This is to notify you that Littelfuse will change the Tube packing quantity for Thyristor TO-220(Isolated and Non-Isolated) and TO-263(D²-PAK) products from 500pcs/box to 1000pcs/box. Detail affected part number list refer to attachment.

PCN Report

Prepared By : Lei Wu, Product Engineer
Date : April 20th, 2020
Device : Thyristor TO-220/TO-263 Tube packing Product Series
Revision : B

3.0 Packing Method:

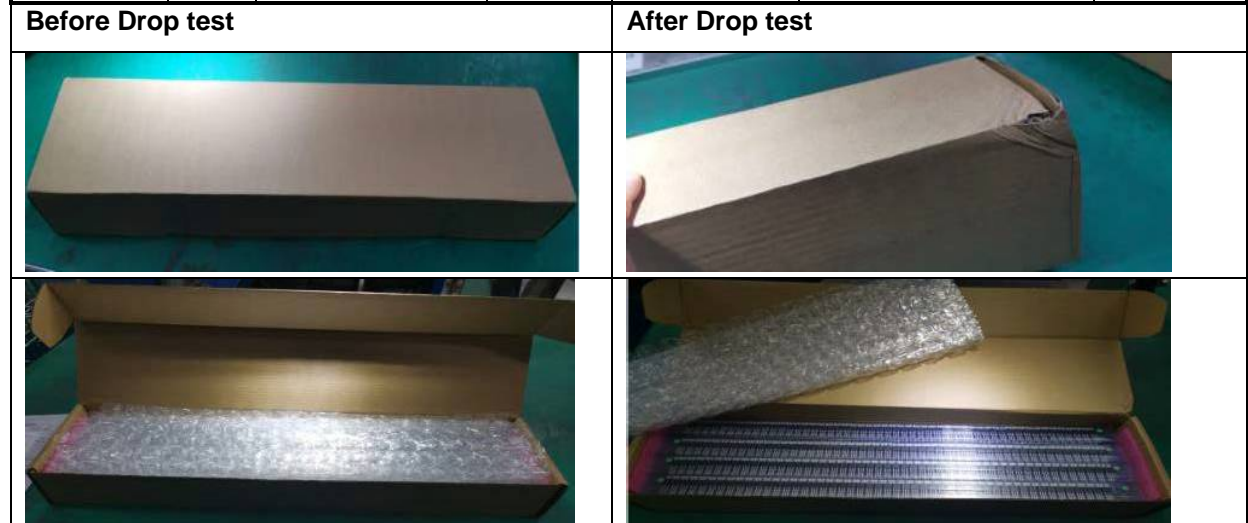
Tube packing quantity will be changed, change it from 500pcs/box to 1000pcs/Box.

6.0 Electrical Characteristic Summary:

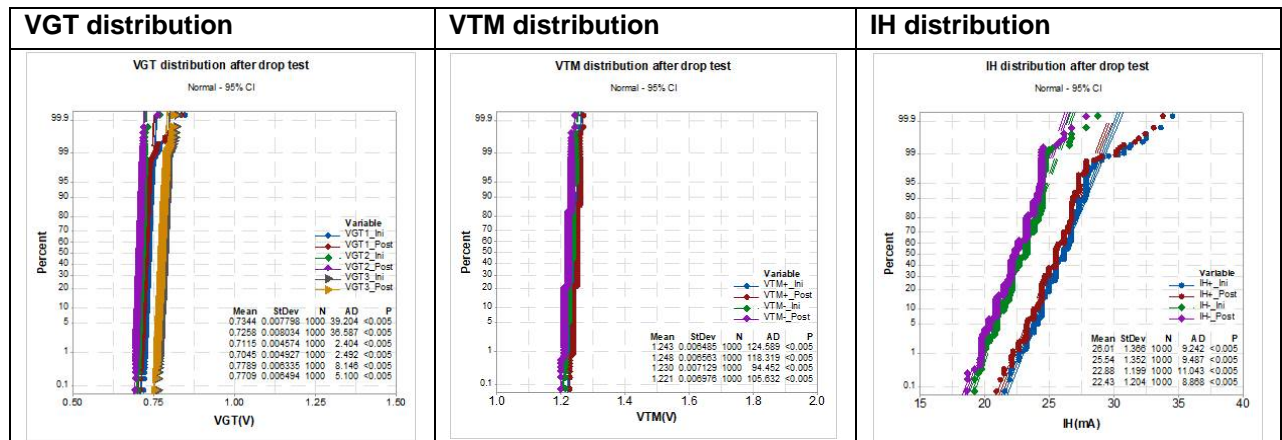
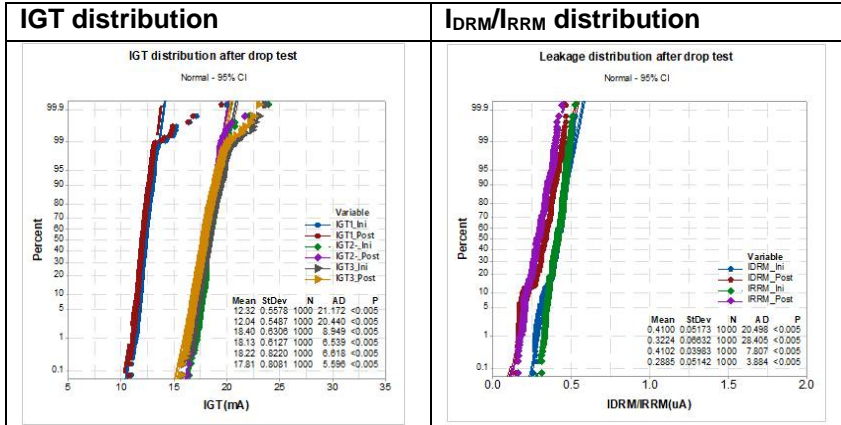
There is no change in electrical characteristics after drop test.
